Access Compliance Report Public Rights-of-Way (Curb Ramps)

Main Street: MADISON_AVE Cross Street: PURDY_ST Location: NW

ADA ID: RPRK220203153612 Ramp Type: Type 4 - Parallel Initial Pass/Fail: Pass Overall Compliance: No Severity Score: 5

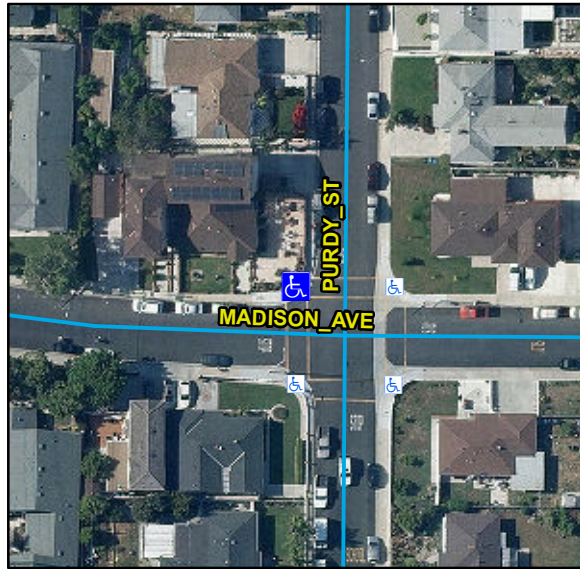
Crossing 1 Slope (%)	4.5		Crossing 2 Slope (%)	6.3
	Crossing 1 Cross Slope (%)	0.1		Crossing 2 Cross Slope (%)	2.3
Yes	Gutter Ponding	No	Yes	Curb Slope	0.5
Yes	Gutter Lip Height (in)	0		Road Run Slope (%)	0.2
No	Gutter Run Slope (%)	6.9		Road Cross Slope (%)	3.7
Yes	Gutter Cross Slope (%)	0.7	Yes	Perpendicular Joint Present	Yes
Yes	Overall Surface Condition	Acceptable			
	Cross Gutter Present?	No		Spandrel Present?	No
	Replace Cross Gutter?	N/A		Replace Spandrel?	N/A

Remove & Replace Gutter.

R304.5.4, STD 1115
